REVISED RESPONSE TO REQUEST FOR ADDITIONAL INFORMATION

APR1400 Design Certification

Docket No. 52-046

RAI No.: 129-8085
SRP Section: 03.08.01 –Concrete Containment
Application Section: 03.08.01
Date of RAI Issue: 08/05/2015

Figure 5-4 Containment Pressure for Loss of RHR (Mode 5)

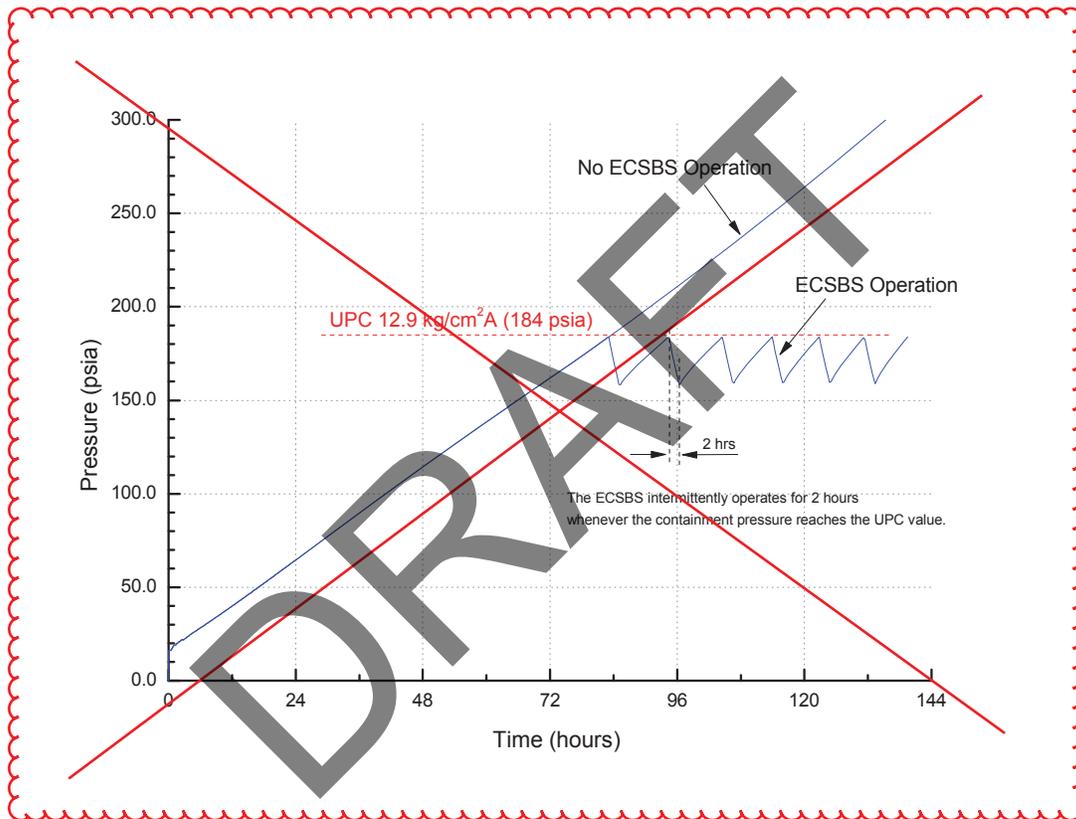
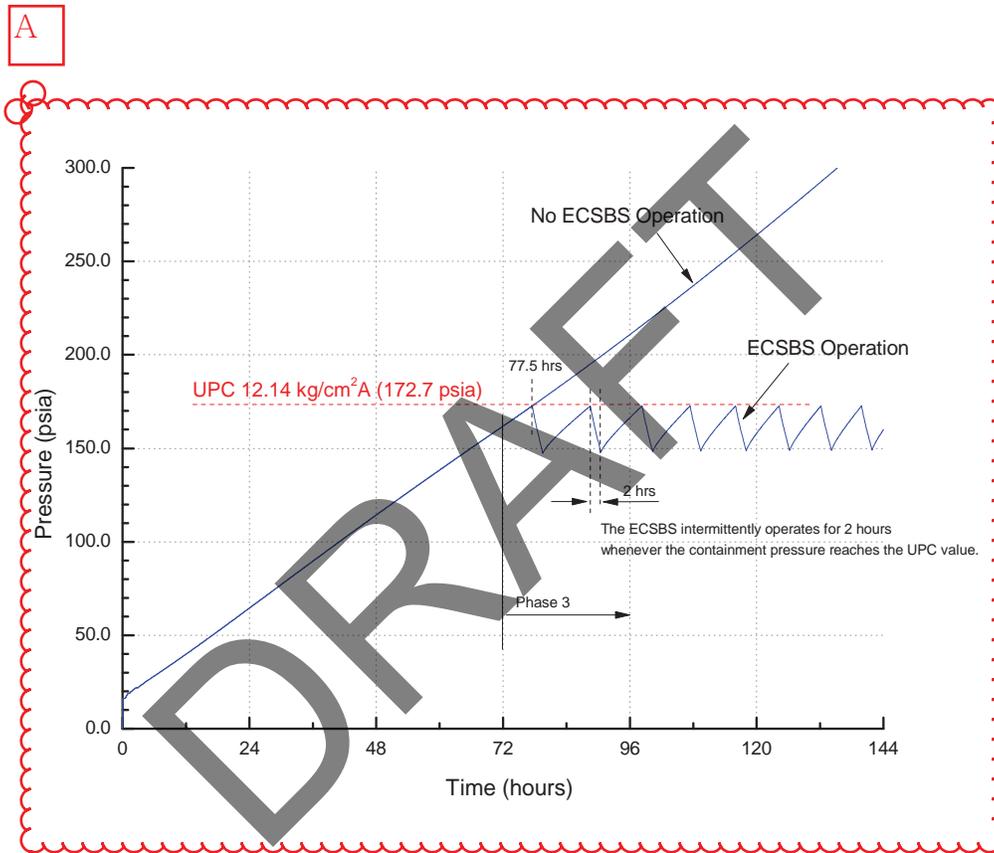
In this operation mode, containment pressure increases consistently from the beginning of the event due to the mass and energy released from the RCS, but it can be maintained below UPC by operating the ECSBS intermittently after reaching UPC at around 3.5 days following the event (see Figure 5-4).

GOTHIC analyses are performed for evaluation of the containment pressure and temperature responses following loss of RHR in mode 5. Figure 5-4 shows that the containment pressure reaches the UPC value in about 3.5 days without ECSBS operation, but with the intermittent operation of ECSBS, containment pressure can be maintained within the UPC limit. Figure 5-5 shows that the containment temperature is maintained well below 185 °C (365 °F), which is less than the upper limit temperature of 196 °C (385 °F) for ensuring the operability of RCS sensors.

11.11 kg/cm² (158 psi)

Replaced with next page, A
